Neasa Hourigan TD
Leinster House
Kildare Street
Dublin 2
D02 XR20

National Transport Authority
Dún Scéine
Harcourt Lane
Dublin 2
D02 WT20

15th December 2020

Re: BusConnects third round of public consultation

3. Accessible on street parking

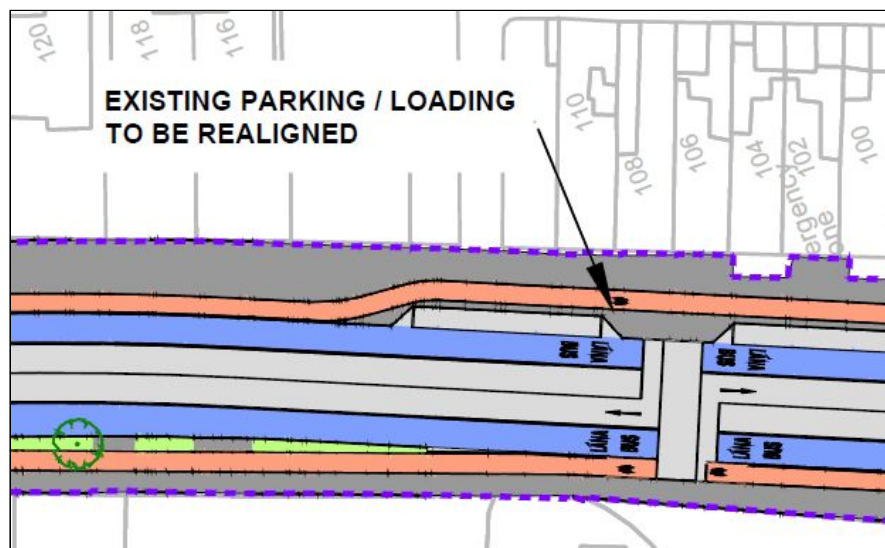
In a similar vein we would like to know what measures are being taken to ensure the safety of cyclists and drivers using parking protected bike lanes.

Some drivers/passengers who will use the parking will be disabled and/or infirm and we should do our best to accommodate such drivers/passengers. We have seen parking protected bike lanes deployed in Dublin Central that appear to have given little regard for how people would safely exit the car (either cycle lane side or traffic side) or where people would cross the cycle lane to get to the footpath.

Likewise it needs to be clear for cyclists where they can expect pedestrians to cross the cycle lane.

4. Cycle lane junctions

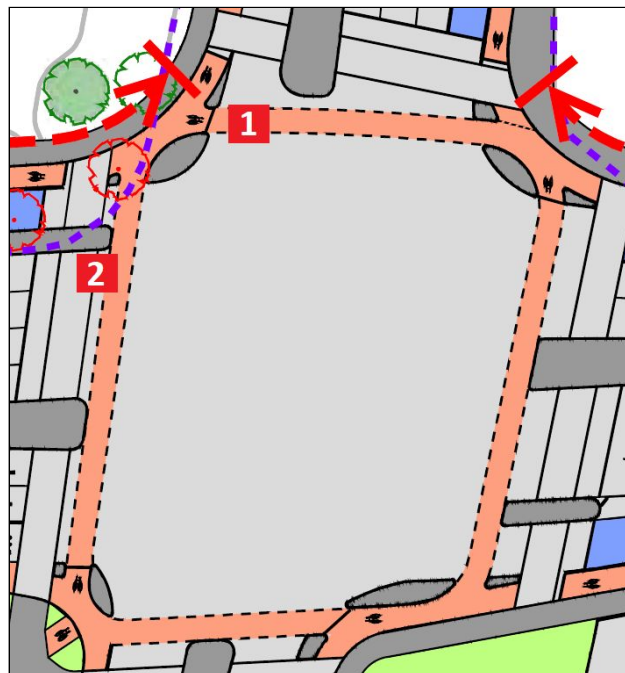
We have concerns about the layout of the cycle junctions. It is not clear from the design how a left turning driver (2 in below diagram) would know to yield to a cyclist (1 in below diagram). Our understanding is that both the driver and the cyclist would have green lights simultaneously. While similar junctions are in place in other jurisdictions, none have been deployed in Ireland as far as we know.

We hope that, if such junctions are deployed, there is a multifaceted effort to ensure their safety including:

1. Signage and design elements at the junctions
2. Driver education initiatives
3. Updates to the RSA driver training materials
